EPC Questions – March 17, 2021

Item 5.1 – R3 Zoning Update

Neighborhood Townhouse

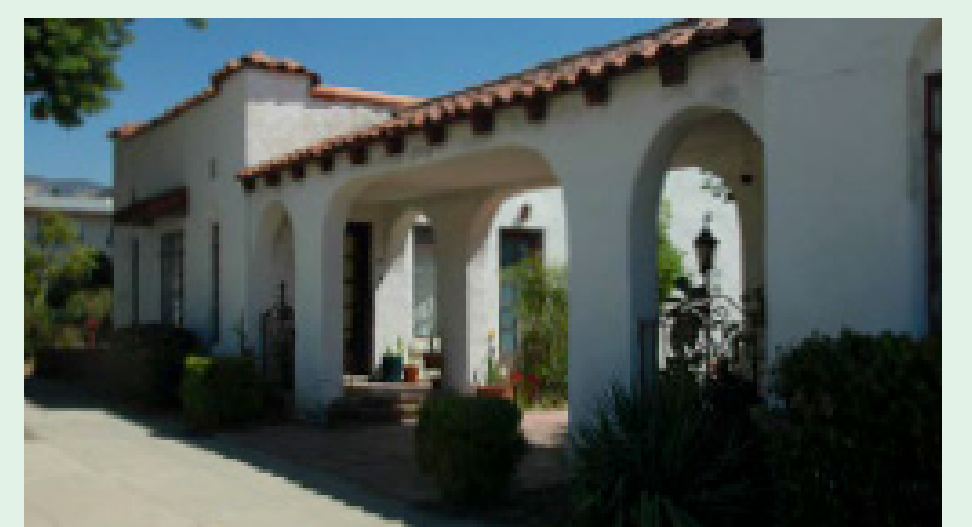
6. Definitions, pictures of all the different R3 building types suggested would be helpful to see

7. Figure 1 - what do cottage court and pocket neighborhood mean?

Attached is additional information regarding these building types.

Please see attached poster.
